Access Compliance Report

Public Rights-of-Way

Intersection ID: 47581	Main Street: ROCK_ISLAND_RD	Cross Street: CHAPECLANE_RD	Location: SE
ADA ID: C2435754750F	Ramp Type: PerpDiag	Initial Pass/Fail: Fail	Overall Compliance: No
			Severity Score: 21.25

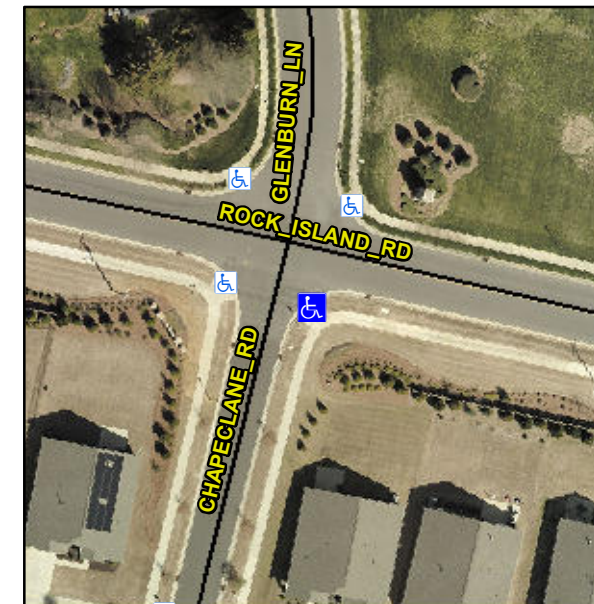
Not Found, R304.5.1, R304.5.3

Compliance	Description	Data	Compliance	Description	Data
N/A	Ramp Length (in)	92.0	Yes	Ramp Slope (%)	6.6
No	Ramp Width (in)	46.5	No	Ramp XSlope (%)	5.5
N/A	Flare Type LT	N/A	N/A	Flare Type RT	N/A
N/A	Flare Slope LT (%)	N/A	N/A	Flare Slope RT (%)	N/A
N/A	Flare Traversable LT?	N/A	N/A	Flare Traversable RT?	N/A
N/A	Landing Length (in)	N/A	N/A	DWS Provided?	N/A
N/A	Landing Width (in)	N/A	N/A	DWS Contrast?	N/A
N/A	Landing Slope (%)	N/A	N/A	DWS Length (in)	N/A
N/A	Landing X Slope (%)	N/A	N/A	DWS Full Width?	N/A
N/A	Landing Curb? (Y/N)	N/A	N/A	DWS Offset (in)	N/A
N/A	Shared Landing?	N/A			
N/A	Gutter Ponding?	N/A	N/A	Gutter Slope (%)	N/A
N/A	Gutter Lip Ht (in)	N/A	N/A	Gutter X Slope (%)	N/A
N/A	Painted X Walk1?	No	N/A	Painted X Walk2?	No
	X Walk 1 Direction	To NE		X Walk 2 Direction	To NW
N/A	X Walk 1 Width (in)	N/A	N/A	X Walk 2 Width (in)	N/A
	X Walk 1 Slope (%)	4.9		X Walk 2 Slope (%)	2.6
	X Walk 1 X Slope (%)	2.0		X Walk 2 X Slope (%)	5.2

Remove & Replace Curb Ramp With Two New Directional Ramps or Equivalent.
